PROJECT: Dexter Community Schools
New Fieldhouse Addition

RE: ADDENDUM 2

Date	March 18, 2026
Project Name	Dexter Community Schools – Dexter High School New Field House
TMP Project No(s).	25026E
Design Release No.	Two (2)
Addendum No.	One (1)

TC503

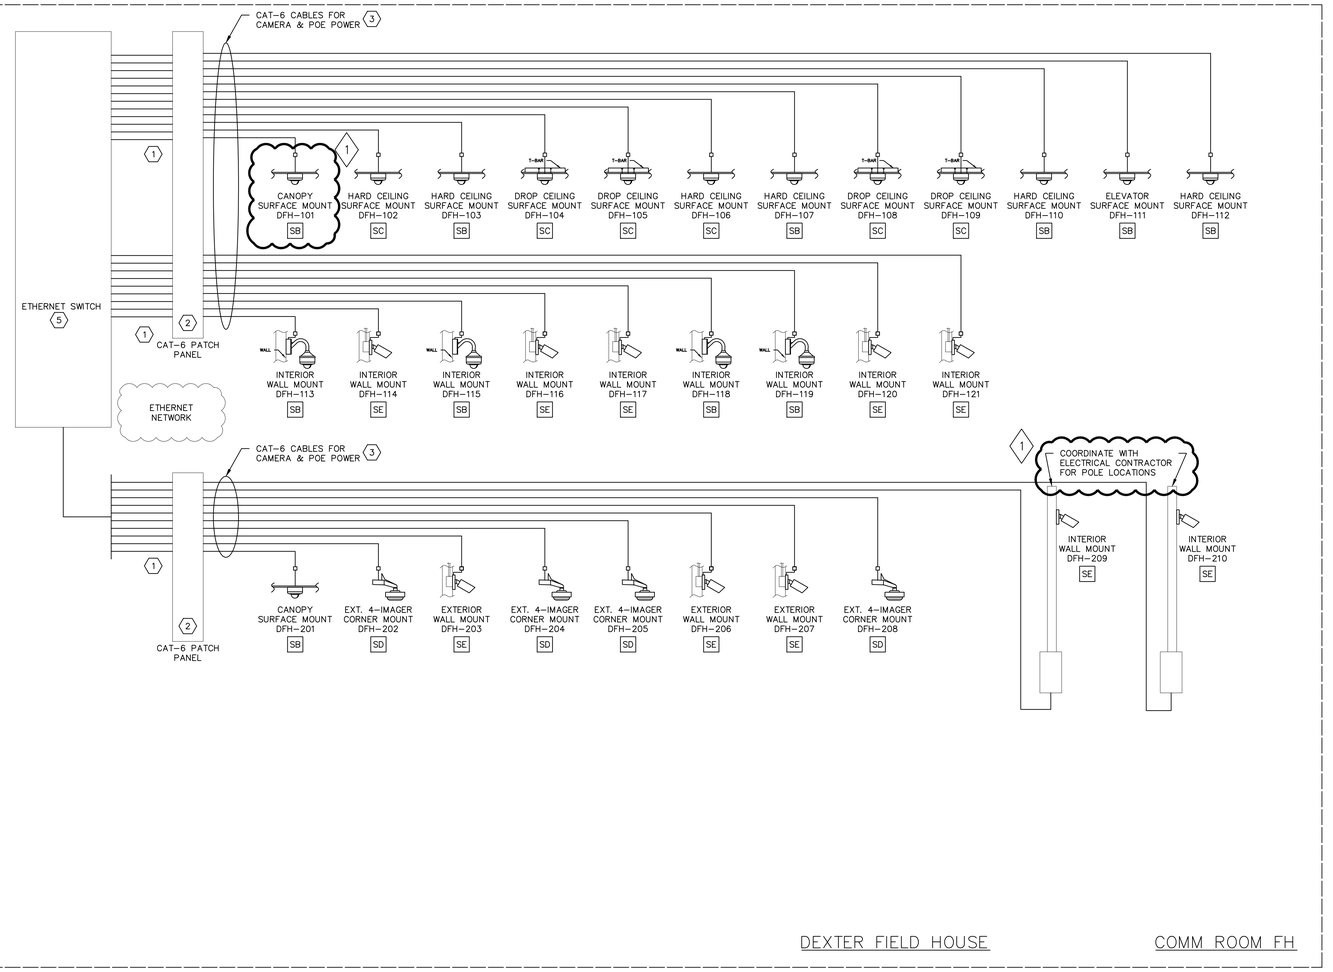
TD-9 Refer to Drawing No. TC503 (reissued):
A. Updated detail with correct info as indicated.

TR101

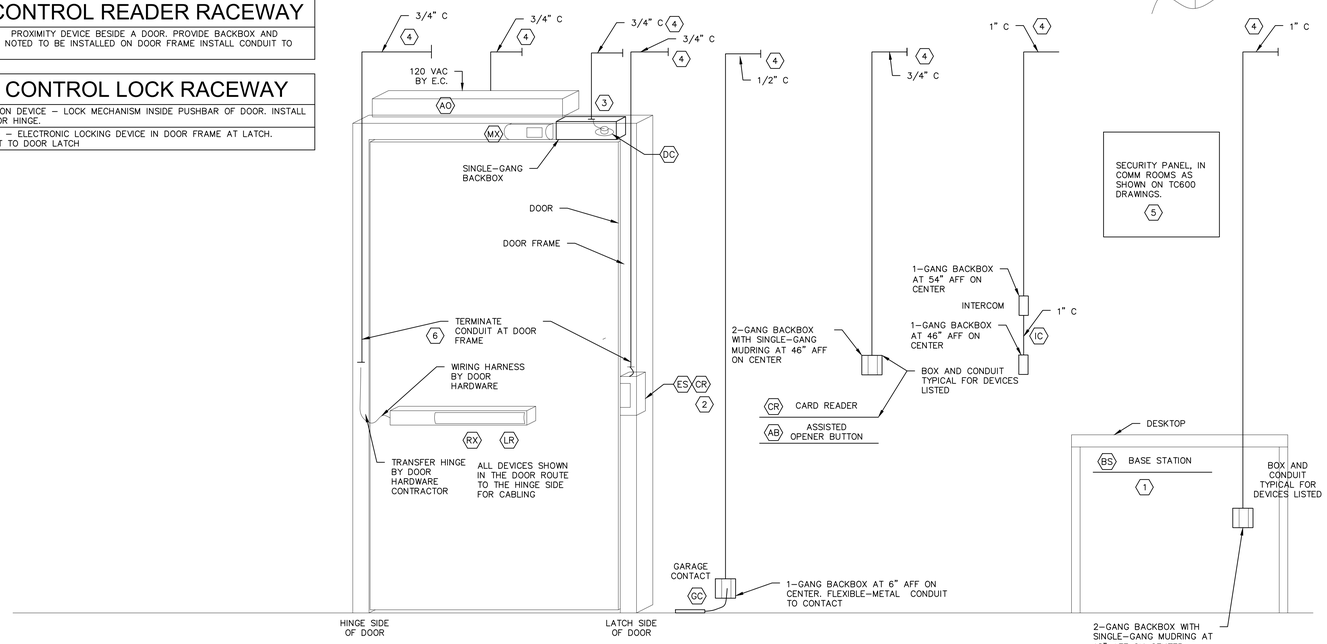
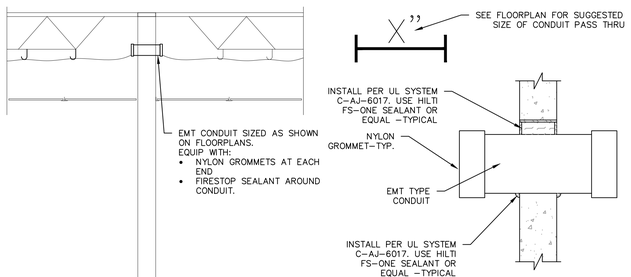
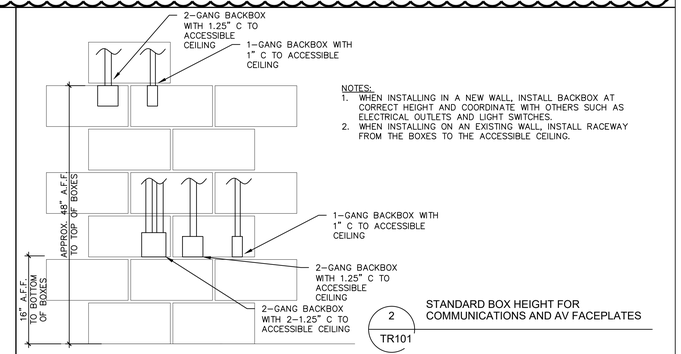
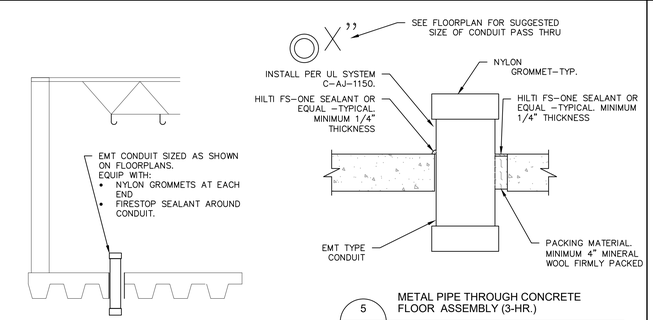
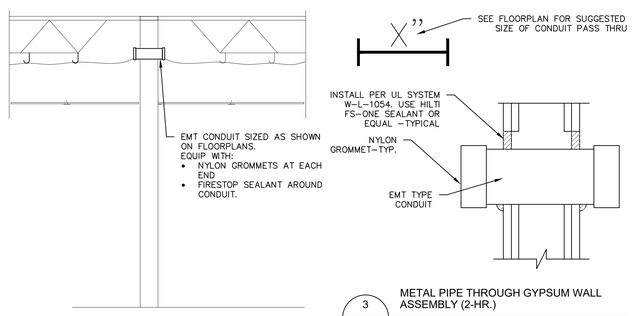
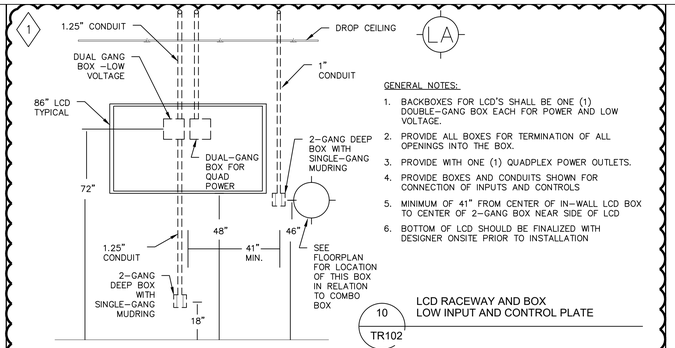
TD-11 Refer to Drawing No. TR101 (reissued):
A. Updated detail with correct info.
